Ref: 1219

PLAN CHANGE 61 – Request for Further Information

Thank you for your letter dated 6 September 2019 requesting further information for Plan Change 61 at the corner of Creyke Road and State Highway 73, Darfield. The information requested has been addressed as follows:

Sheet 1

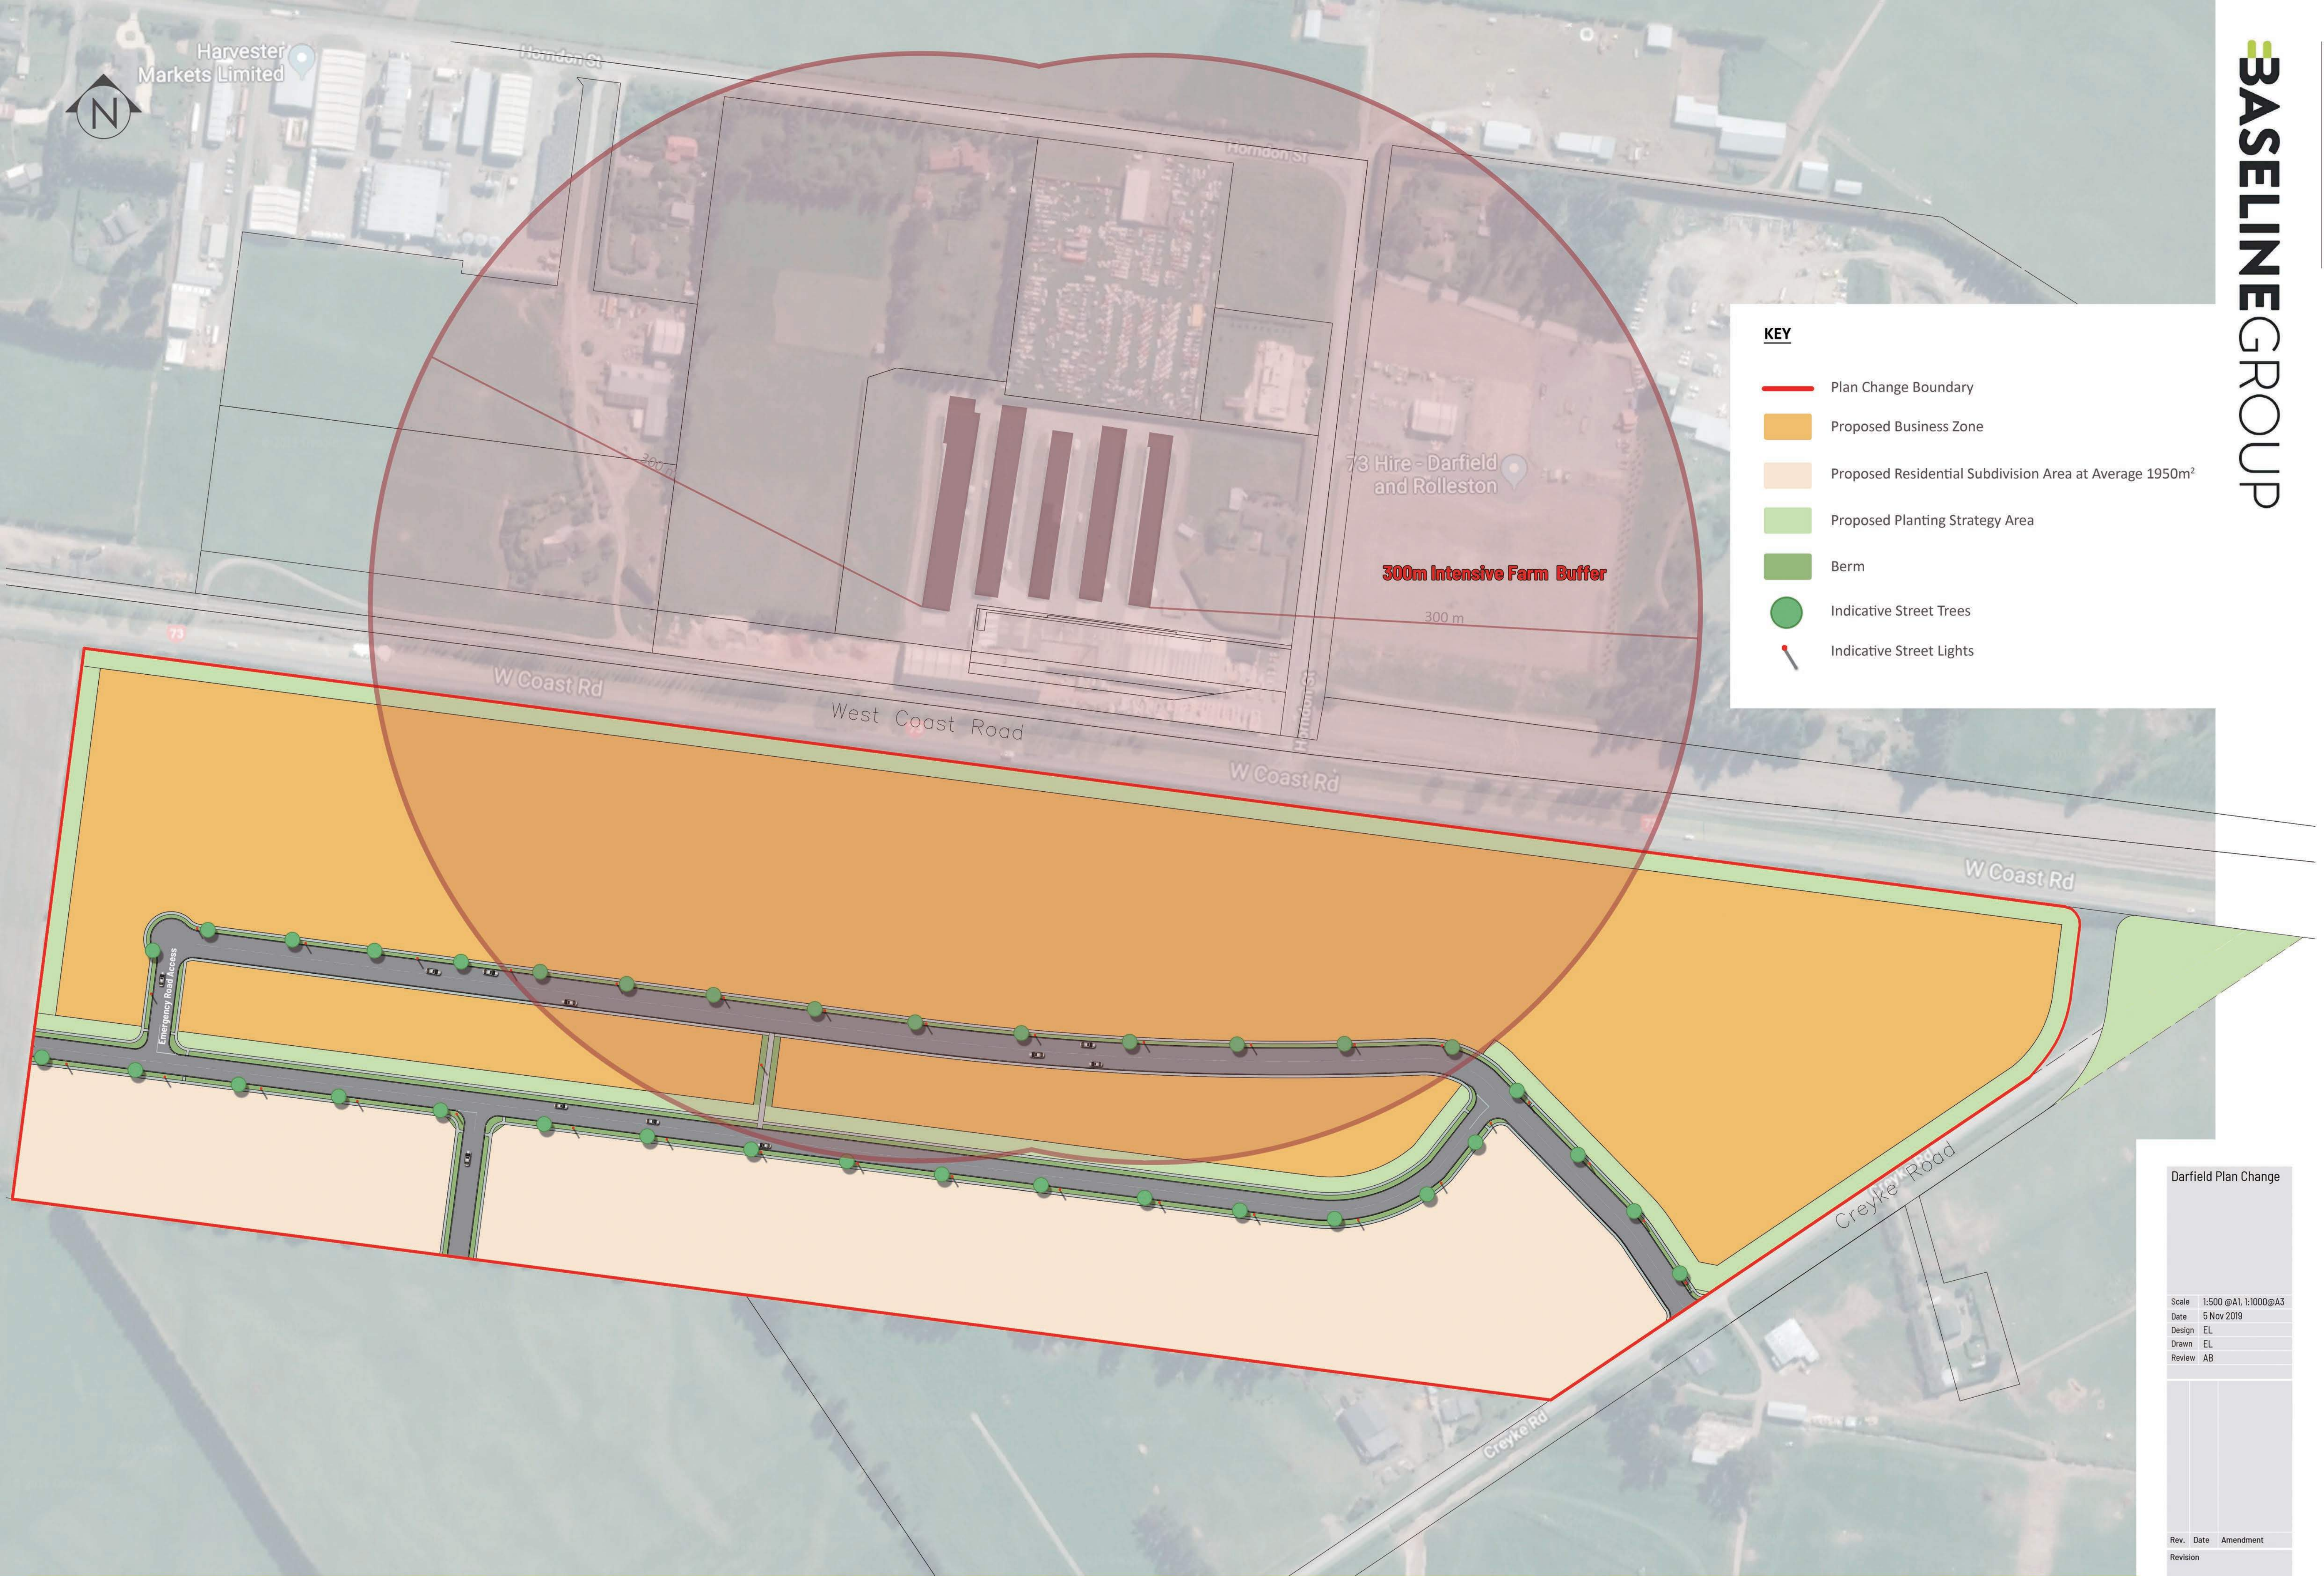
- 1. The site is situated next to a consented subdivision, including Ascot Park and 339 Creyke Rd.*
- 2. The industrial areas over SH73. Please overlay the 300m buffer from the intensive farm to the north.*
- 3. Access to reserves and commercial areas.*
- 4. How it fits within the Darfield Township.*

A separate plan showing the theoretical intensive farm 300 m buffer is also attached. While a 300 m buffer has been applied from the intensive farming activity to show the context for this, it is noted that this farming activity occurs within the business zone and as such is not technically subject to a 300 m setback provision. Intensive farming activities are not anticipated or contemplated within urban areas within the Townships volume of the District Plan and the 300 m buffer is a rule applied within the rural zone under the District Plan. Nevertheless, the attached ODP indicates where this 300 m setback would apply if applicable and shows that any proposed residential zone would site outside this buffer zone.

Darfield

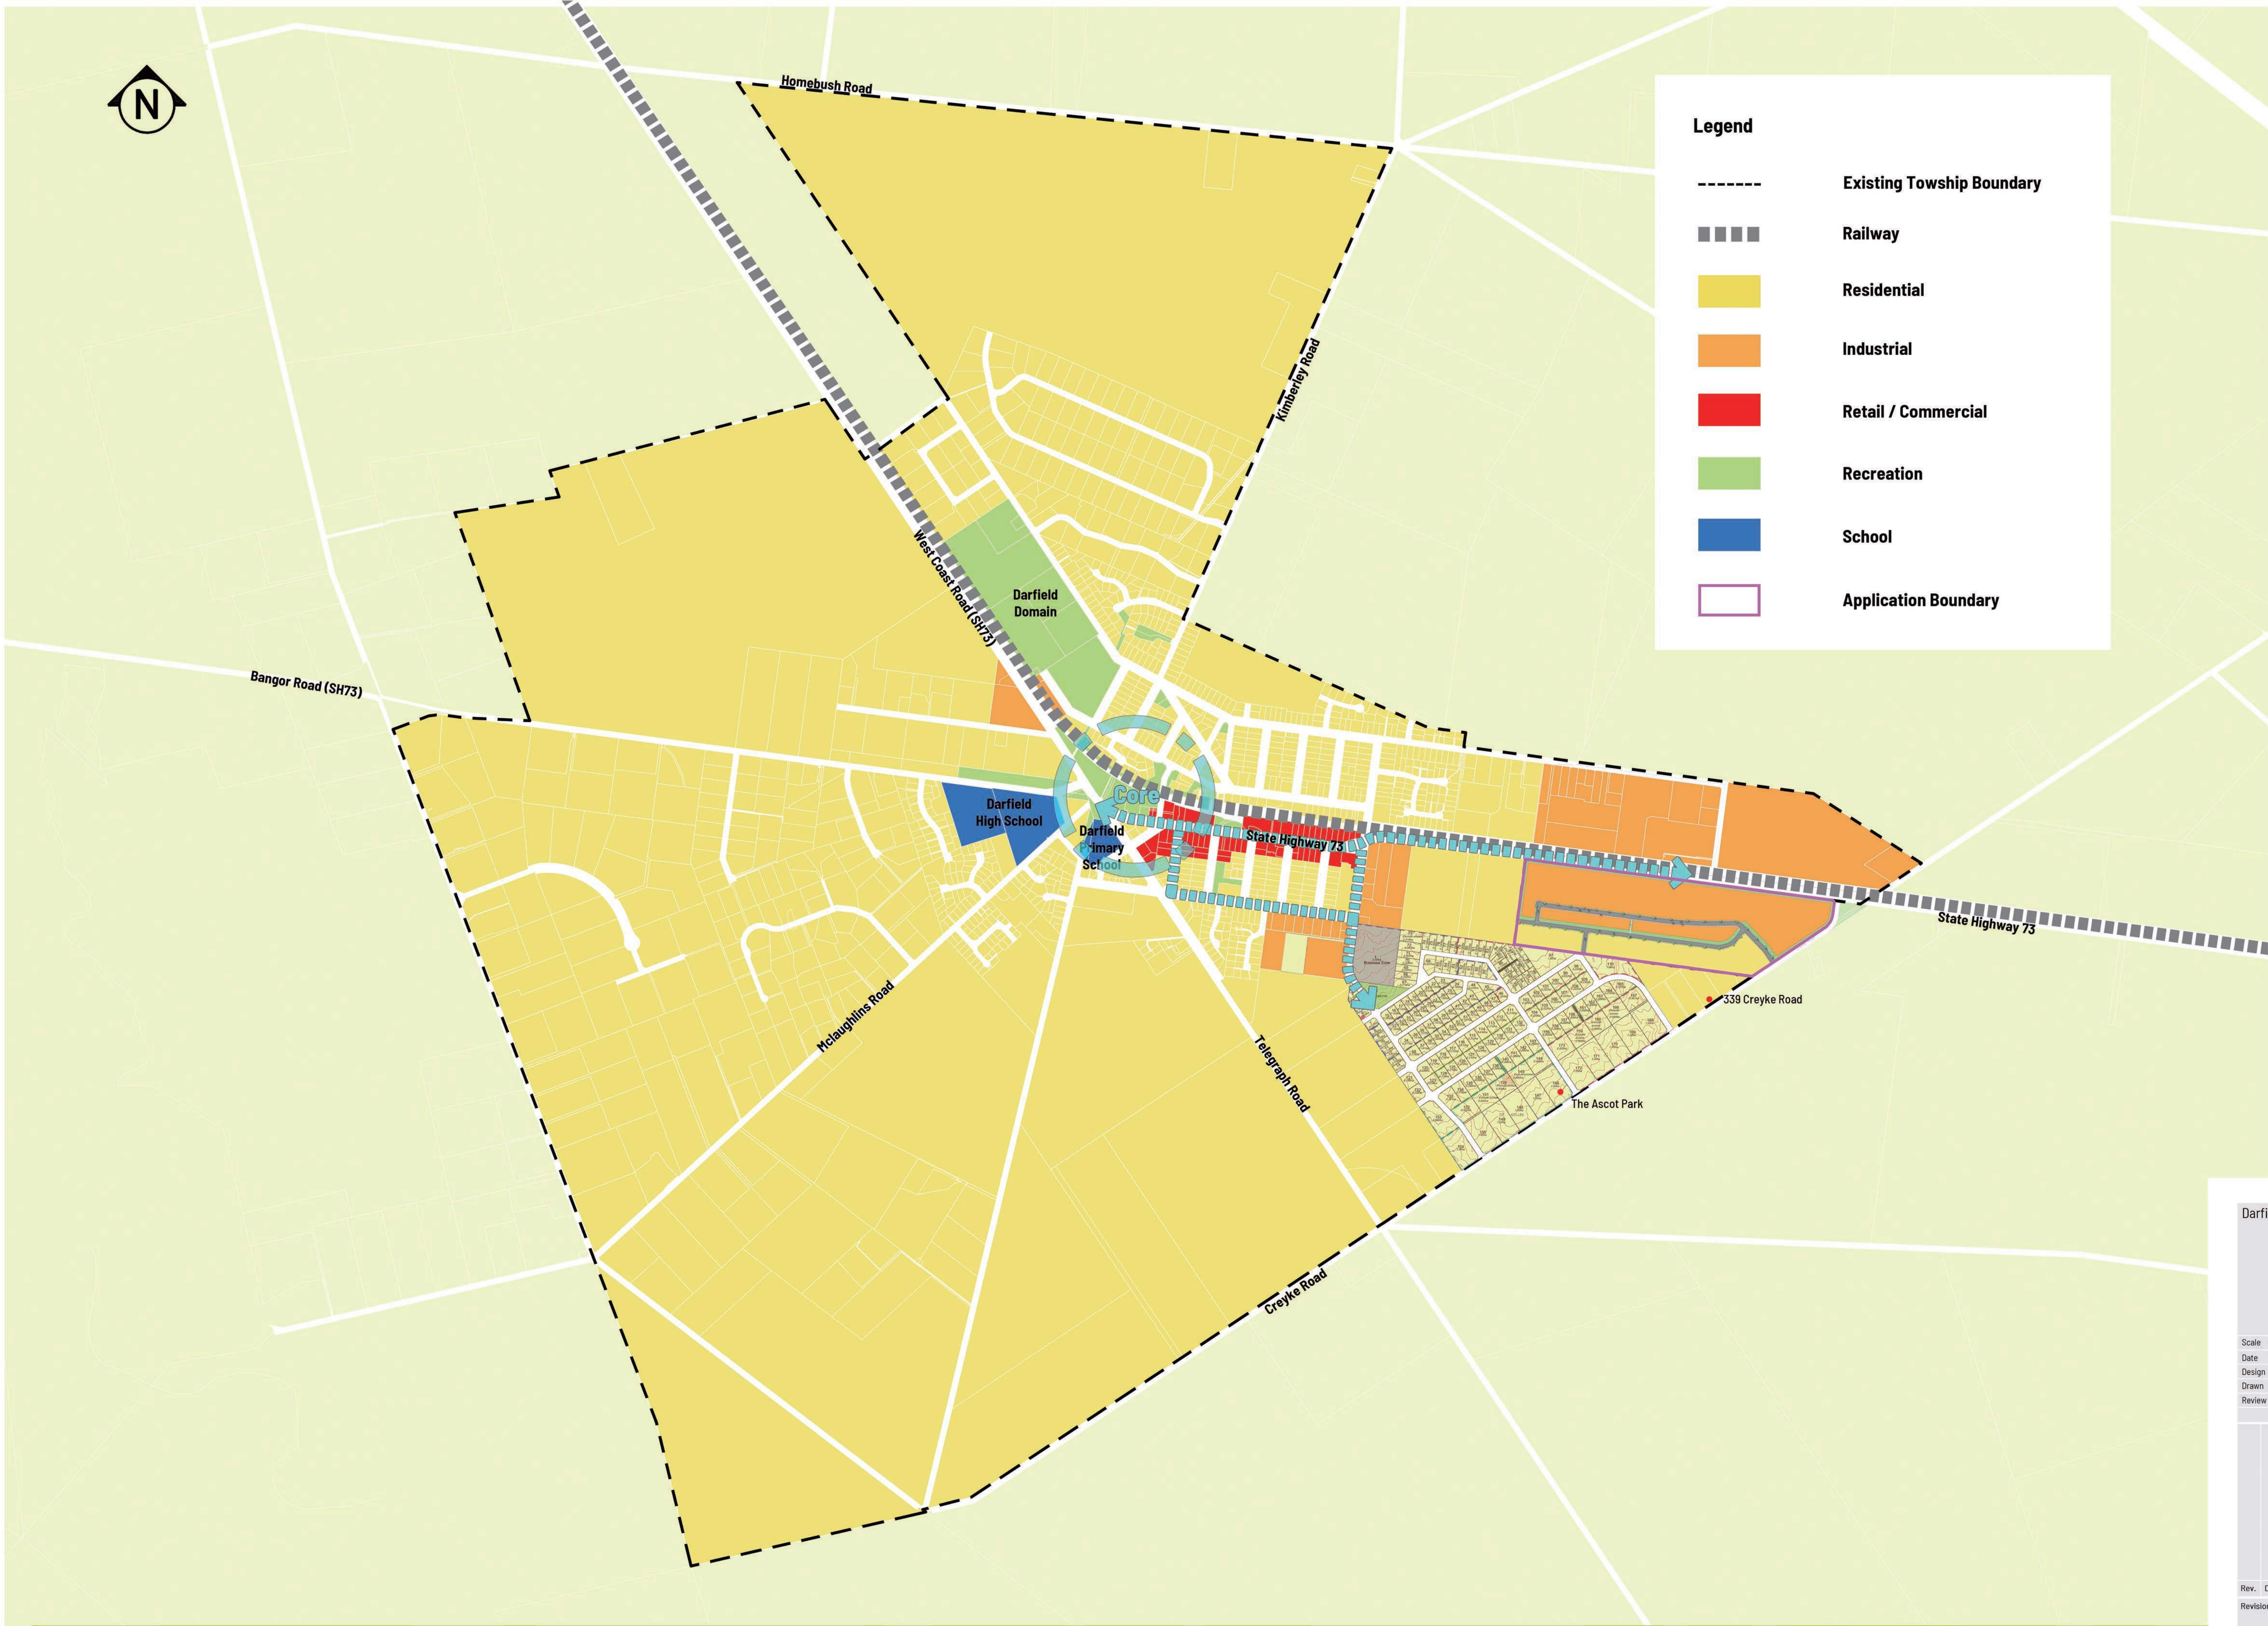
The context map is required to show how it fits with the surrounding development and township. It should show:

The ODP and ascot park development have been overlaid onto the Darfield Context plan from the Malvern Area Plan for Darfield to show the context of the development in the surrounding existing environment. This shows the existing zoning, road layout and connections, reserve areas and commercial business areas.

This context maps shows the existing and proposed ascot park reserve areas within Darfield. The context map provides an overview of how the development fits with the wider Darfield. It is intended that the proposal will include Business 2 Zoned land on the opposite side of SH73 from the existing area providing a large industrial zone area contained cohesively at the eastern end of the township. This is sufficiently close enough to enable walking and cycling opportunities for people to work in these areas, but appropriate separation distance to avoid adverse reverse sensitivity effects with surrounding residential activities. This site might provide for activities such as a supermarket or large format retail activities that service the wider rural community, where space for car parking is necessary and cannot be accommodated elsewhere in Darfield's Central Business Zoned land.
